UNITED STATES PATENT AND TRADEMARK OFFICE

APPLICATION NO.	FILING DATE	FIRST NAMED INVENTOR	ATTORNEY DOCKET NO.	CONFIRMATION NO.
10/605,892	11/04/2003	Chao-Kang Li	AOIP0008USA	2891

Office Action Summary	Application No.		Applicant(s)	
	10/605,892		LI, CHAO-KANG	
	Examiner		Art Unit	
	Noah C. Hawk		3637

DETAILED ACTION

Le et al. Figure 10

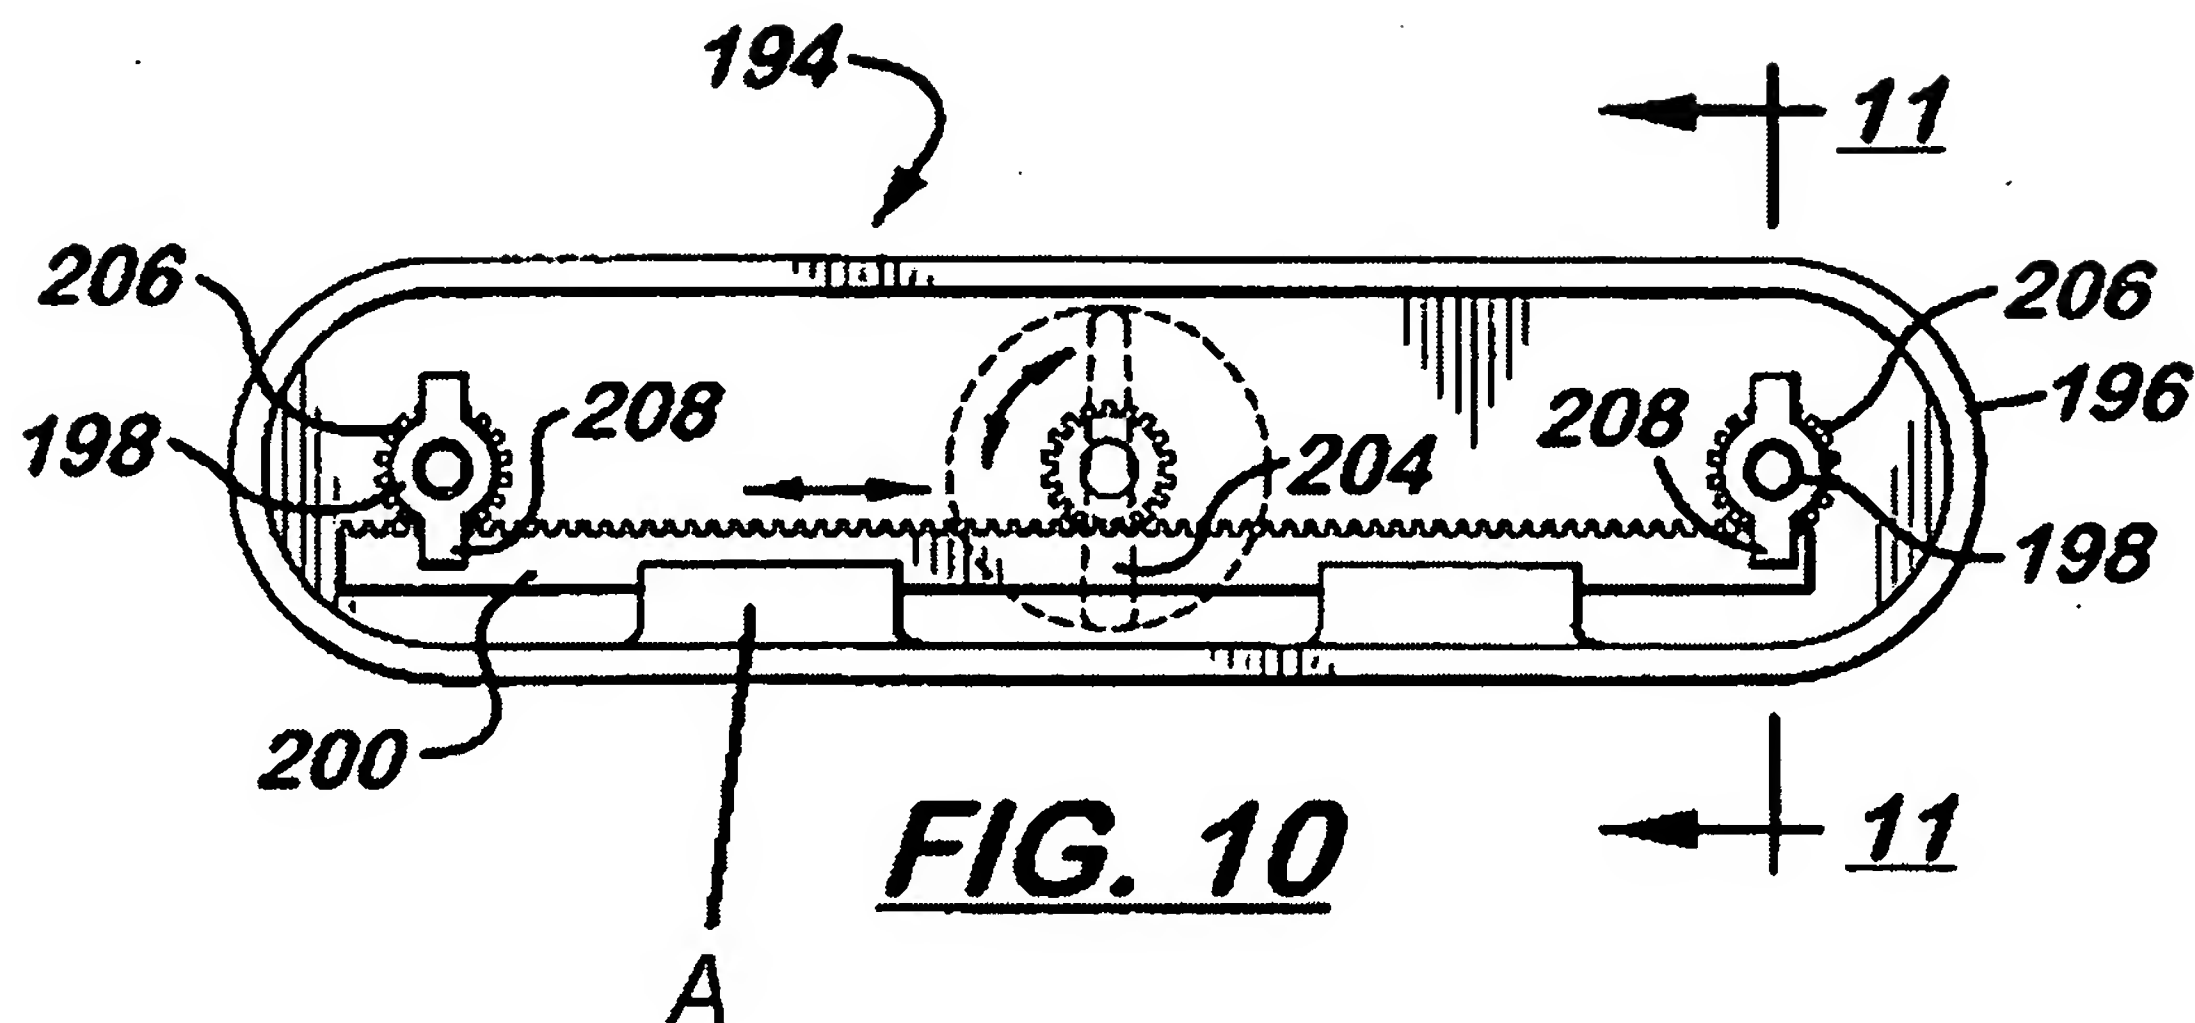
2. Claims 1, 2, 4, 7, 9, 10, 12, and 15 are rejected under 35 U.S.C. 102(b) as being anticipated by Le et al. in US Patent 6293636.
3. Regarding Claim 1, Le et al. teach a storage device fastening apparatus, the storage device having a plurality of first holes (138), the apparatus comprising a frame (102) installed inside a casing (152) with a plurality of second holes (140), a second hook (182) located on the side of the frame not facing the storage device, a fastening base (194) detachably installed on the frame having a plurality of bumps (198) formed

at positions corresponding to the second holes for penetrating through the second holes and into the first holes and a sliding portion (202) movably installed on the fastening base having a first hook (208) wherein the sliding portion is capable of residing at a first position and a second position so that the first hook is separated from the second hook in the first position and the first hook and the second hook are fastened to each other in the second position (see Le et al., column 8, lines 15-19).

4. Regarding Claim 9, Le et al. further teach a storage device fastening apparatus, the storage device having two sides with a plurality of first holes (138) on each side, the apparatus comprising a first frame (128) with a least a first loading portion (best seen in Figure 3, 136) and a plurality of first elastic bodies with bumps (see Le et al., column 5, lines 5-12) corresponding to a first hole on one side of the storage device.

5. Regarding Claims 2 and 10, Le et al. further teach a frame (126) comprising at least a loading portion (best seen in Figure 9, 136) on the side of the frame facing the storage device for loading the storage device.

6. Regarding Claims 4 and 12, Le et al. further teach a sliding portion (202) having a first track (200) and a fastening base (194) having a second track (A) corresponding to the first track so that the sliding portion moves with respect to the fastening base along the first and second tracks between the first and second positions.

7. Regarding Claims 7 and 15, Le et al. further teach a fastening base (194) with a first stop block and second stop block (180) on the fastening base for preventing the sliding portion from detaching from the fastening base during movement (see Le et al., column 7, lines 29-32).

Chen et al. Figure 1

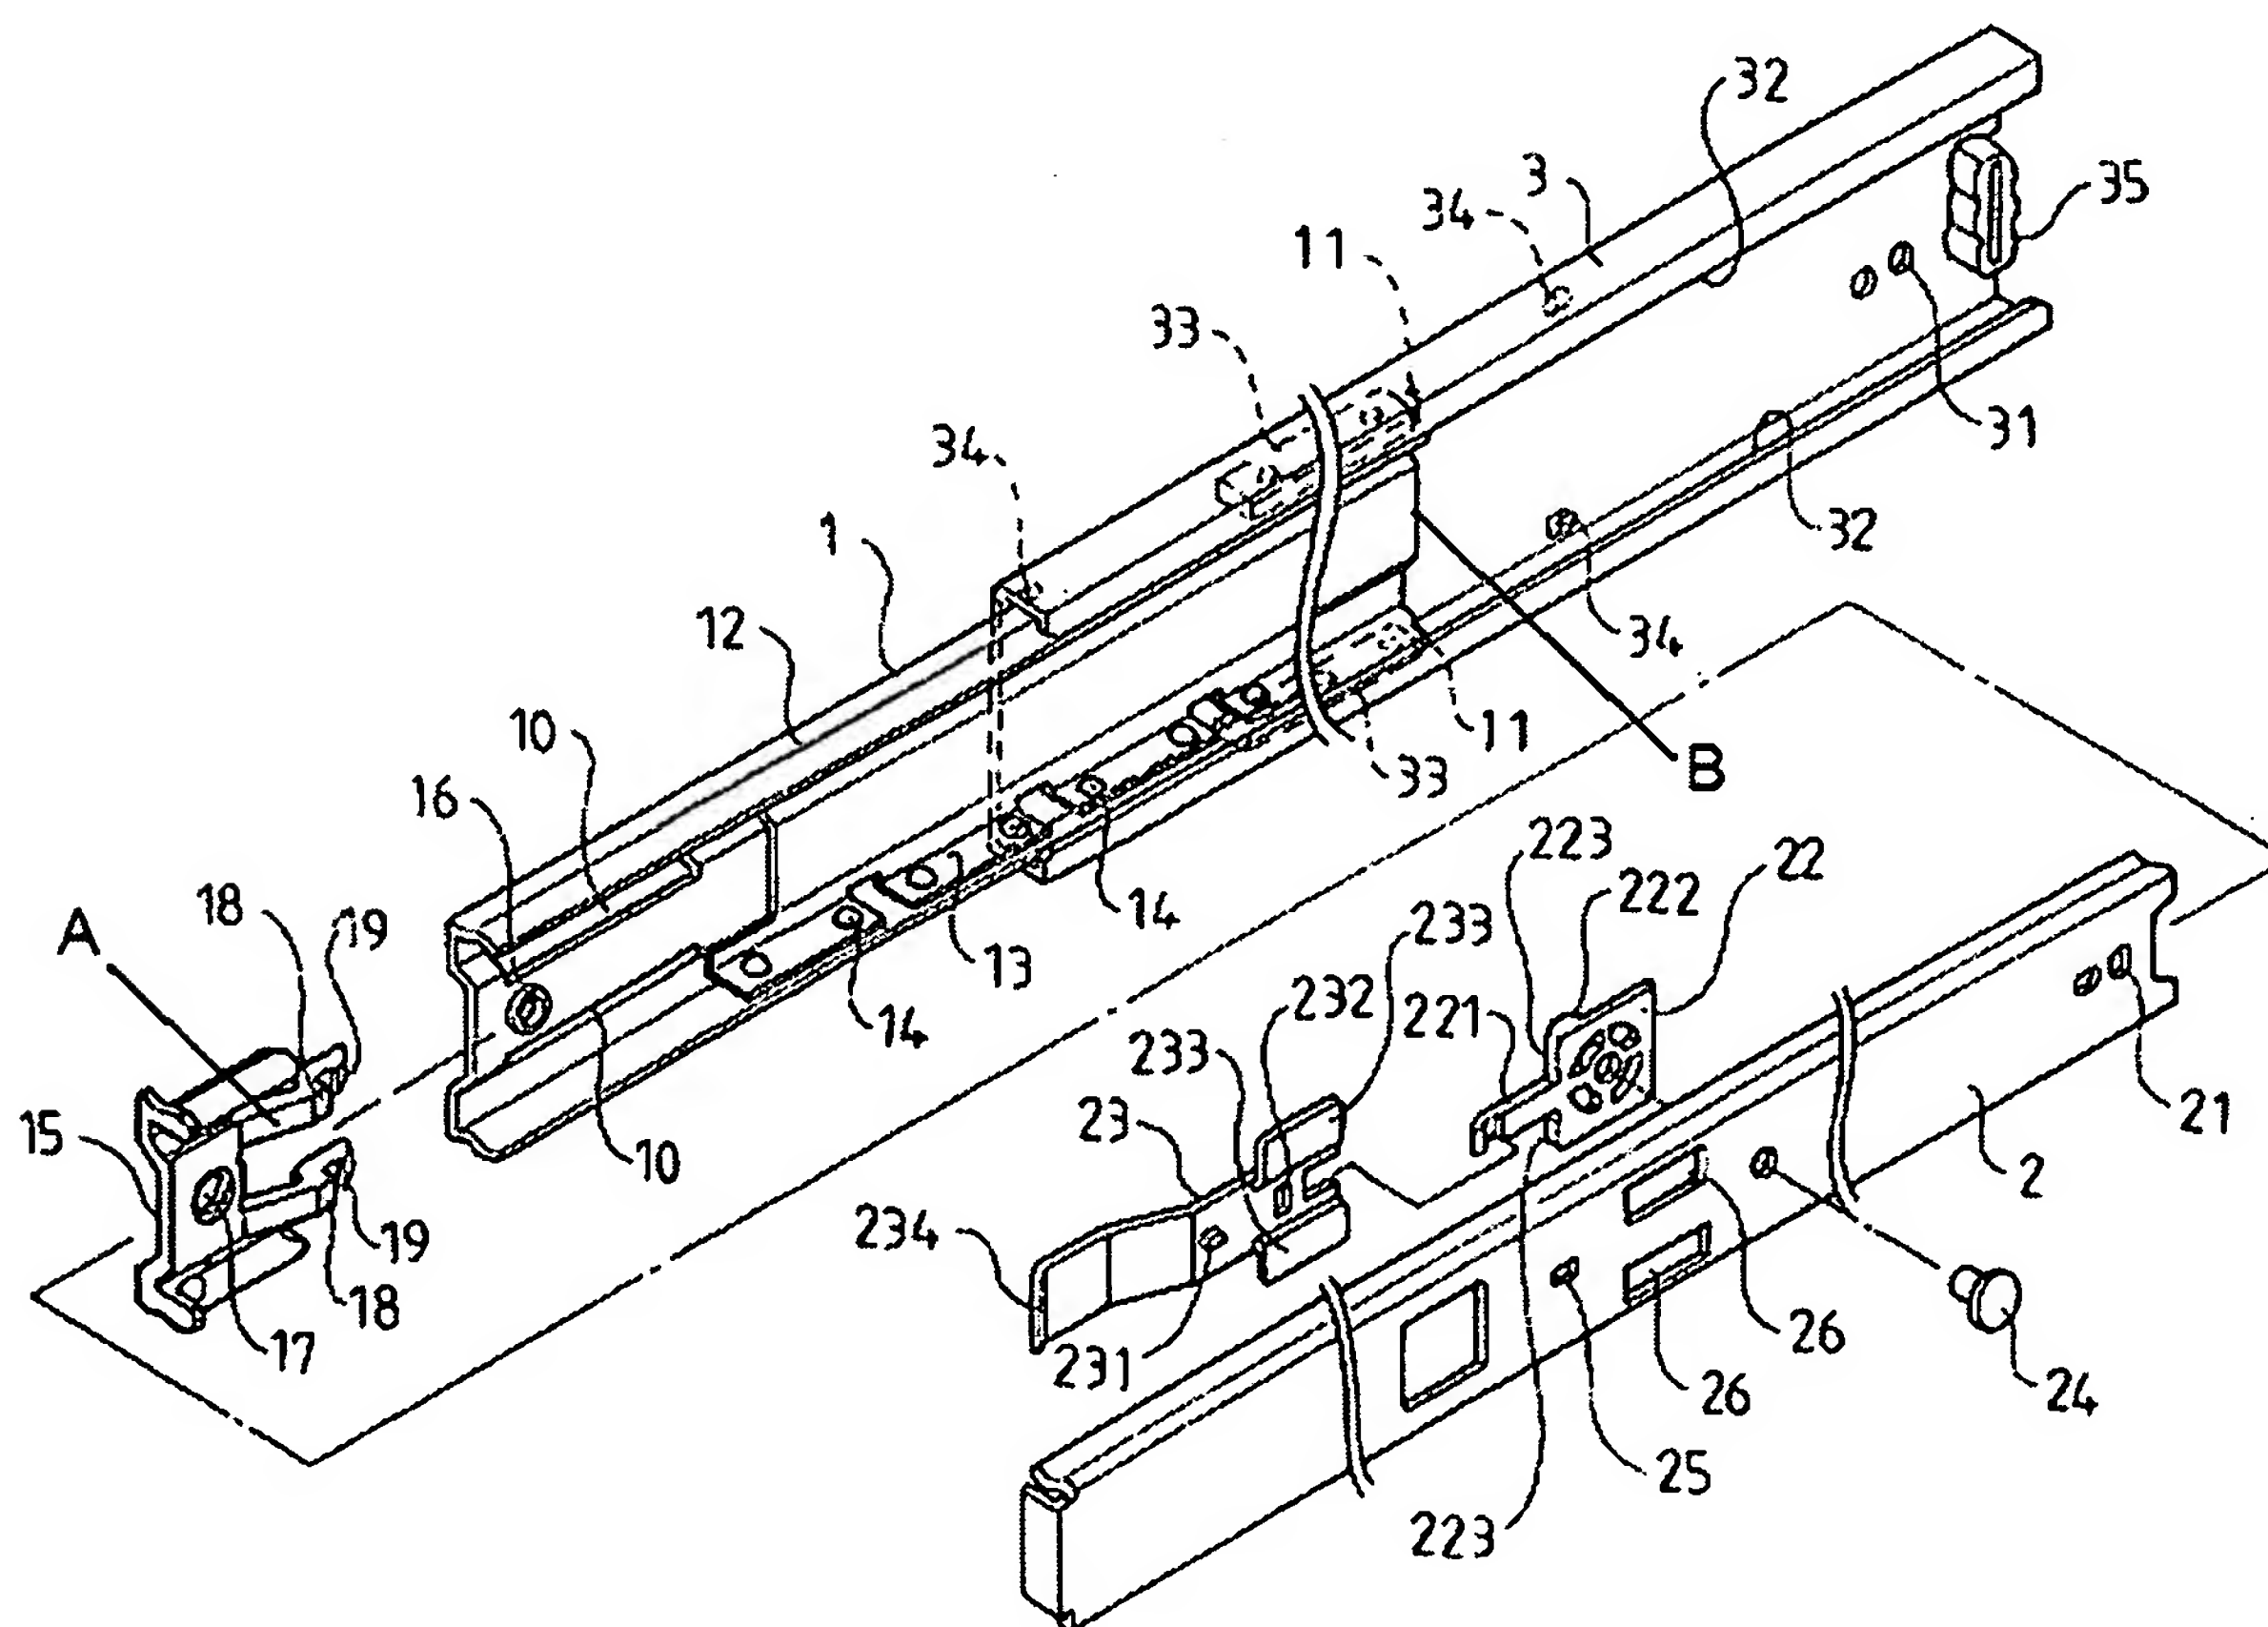
12. Regarding Claims 6 and 14, Le et al. do not disclose a first assembly error prevention assembly or a second assembly error prevention structure. Chen et al. disclose a sliding device with a sliding portion (1) having a first assembly error prevention device (B) attached to a fastening base (3) with a second assembly error prevention device (35). It would have been obvious to one of ordinary skill in the art at

the time of invention to use first and second assembly error prevention devices as taught by Chen et al. in order to prevent assembly error.

13. Regarding Claims 8 and 16, Le et al. do not disclose a first stop block with an inclined surface. Chen et al. disclose a sliding device with a stop block (15) having an inclined surface (A). It would have been obvious to one of ordinary skill in the art at the time of invention to use a stop block with an inclined surface as taught by Chen et al. in order to assist in the assembly of the sliding portion with the fastening base.
